THE MEDICAL CENTER OF AURORA

CT / X-RAY INSTALLATION

Code violations that are found during inspection are required to be corrected. Permit issuance does not grant approval of a code violation. **2009 IBC 105.4**

SHEET TITLE:
HVAC PLAN

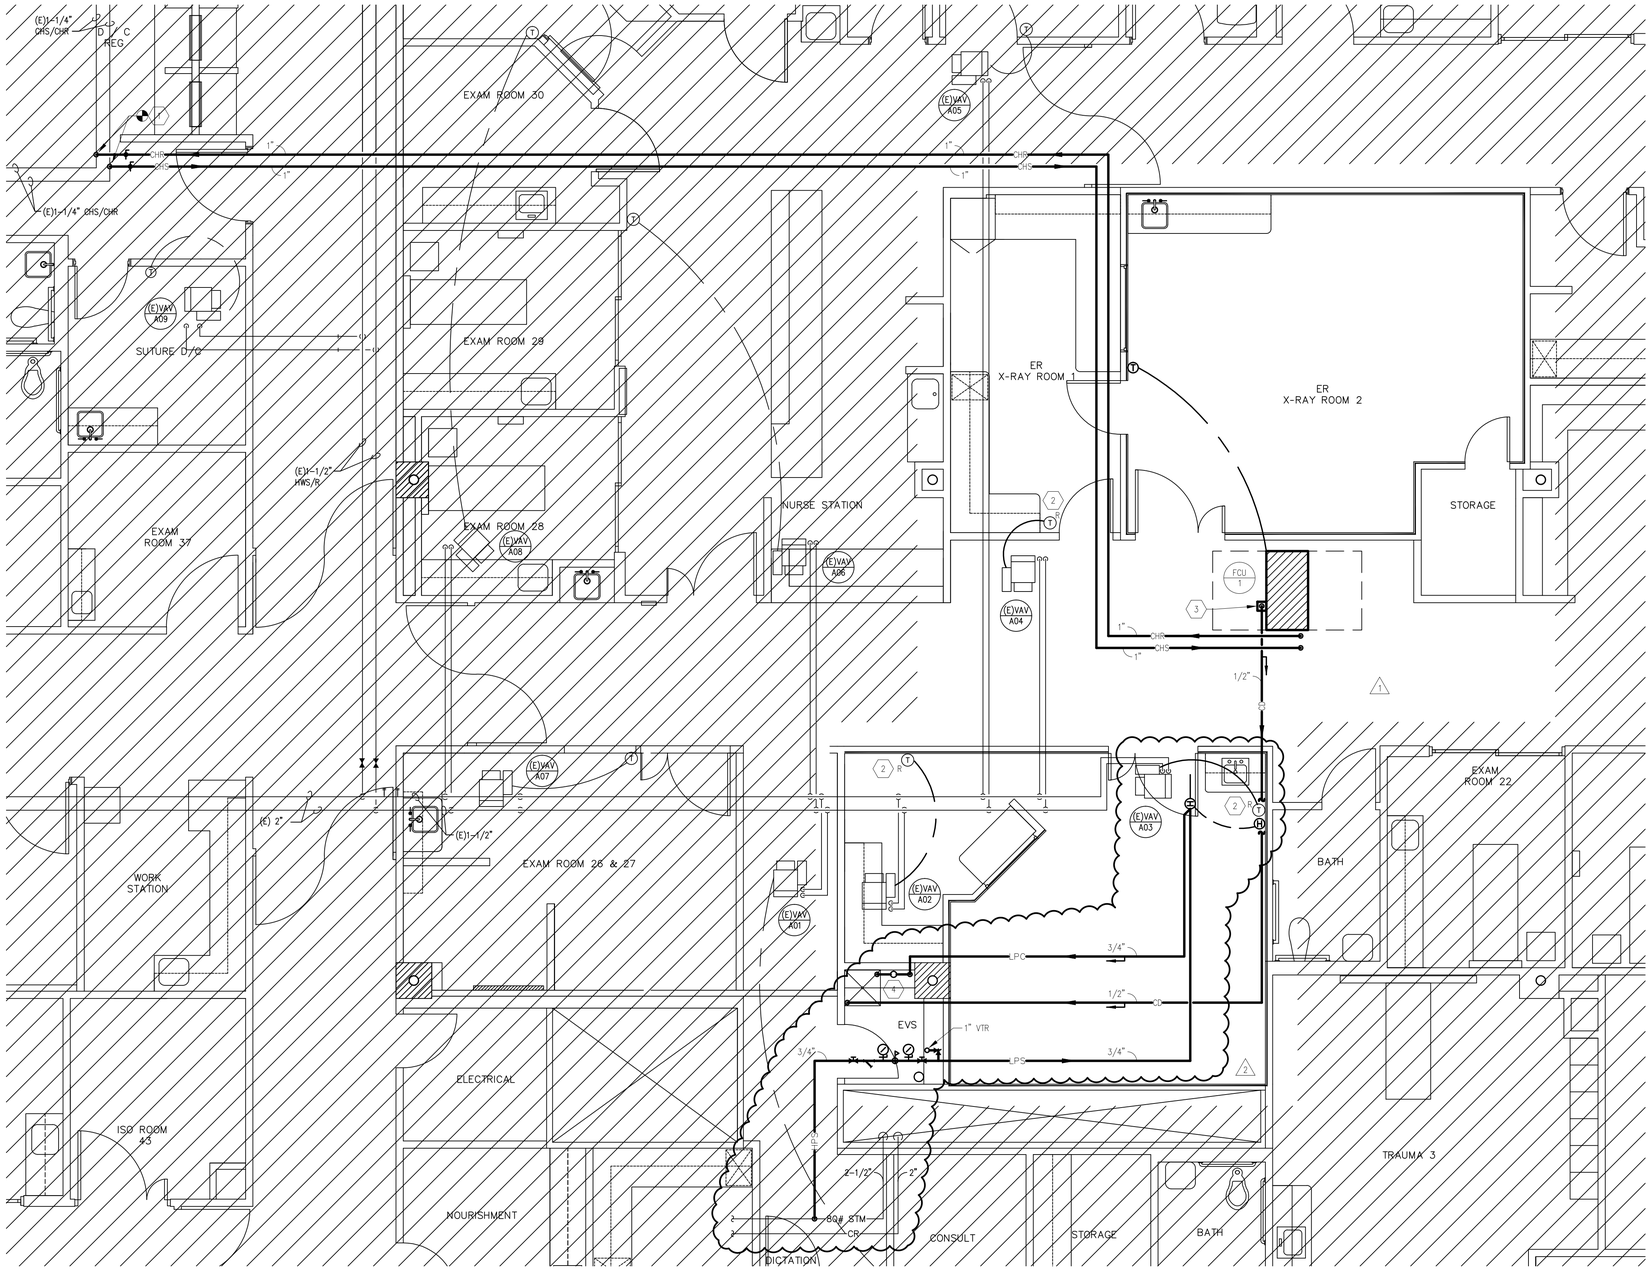
Provide proof of a flame spread <26 and smoke development <51 for any materials used within a plenum.
2009 IMC 602.2.1

SHEET TITLE:
HVAC PIPING PLAN

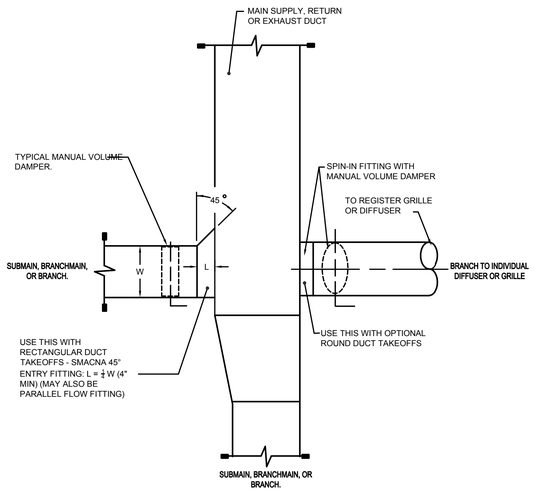
Provide proof of a flame spread <26 and smoke development <51 for any materials used within a plenum.
2009 IMC 602.2.1

SHEET NO.:
E-4.0

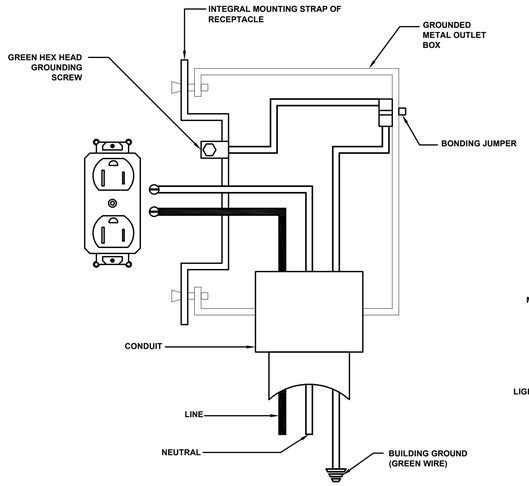
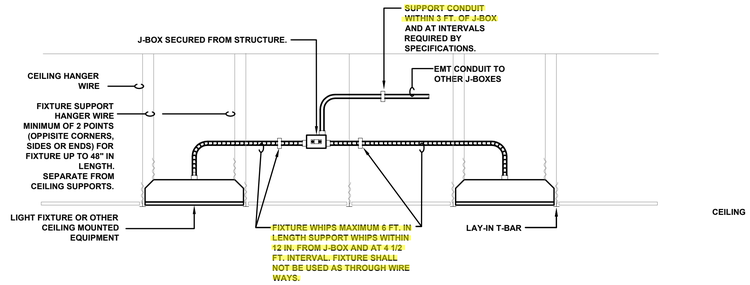
Install electrical connections per 2014 NEC 110.14, identify disconnects per 2014 NEC 110.22 and provide working space around electrical equipment per 2014 NEC 110.26.

Locate the required overcurrent protection per 2014 NEC 240.21.

X-RAY SUPPORT FRAMING PLAN

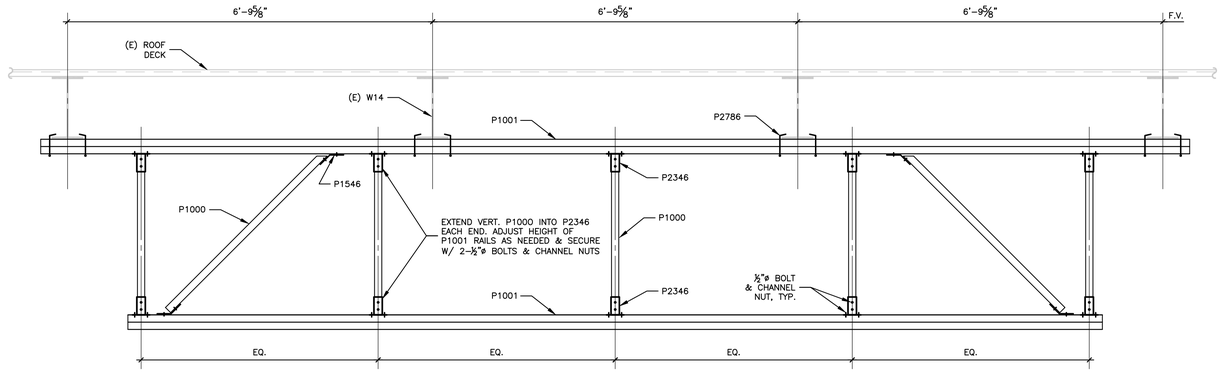
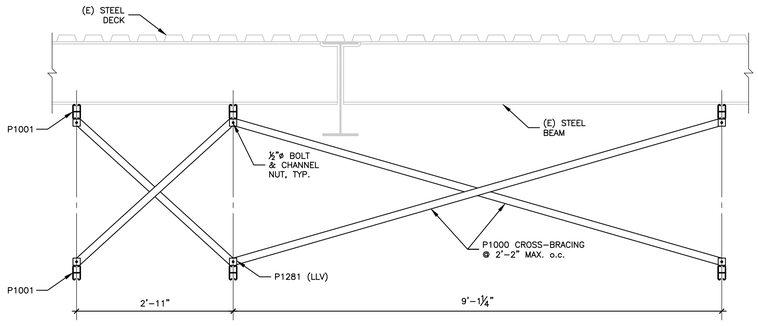
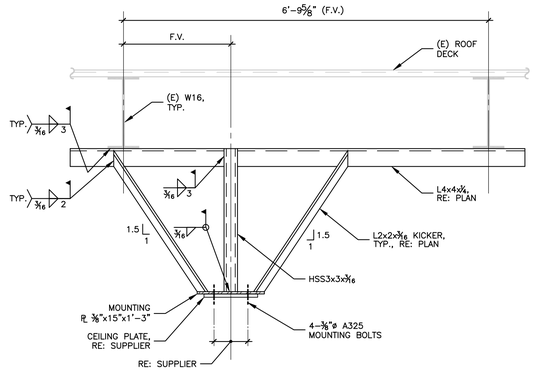
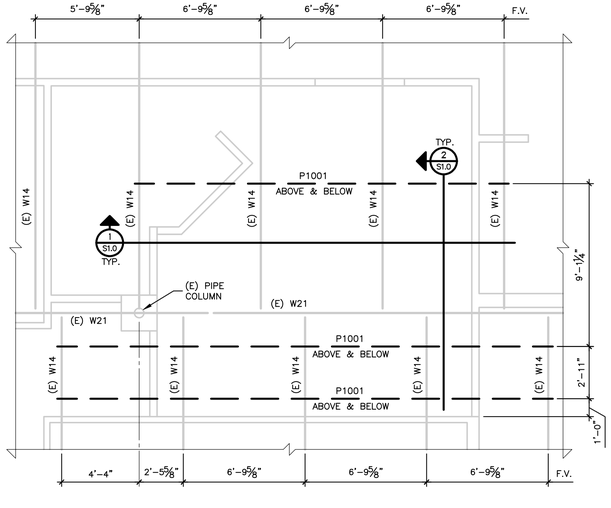
Structural plan review is limited to a general survey for code compliance. No review is implied nor was undertaken to verify structural adequacy.
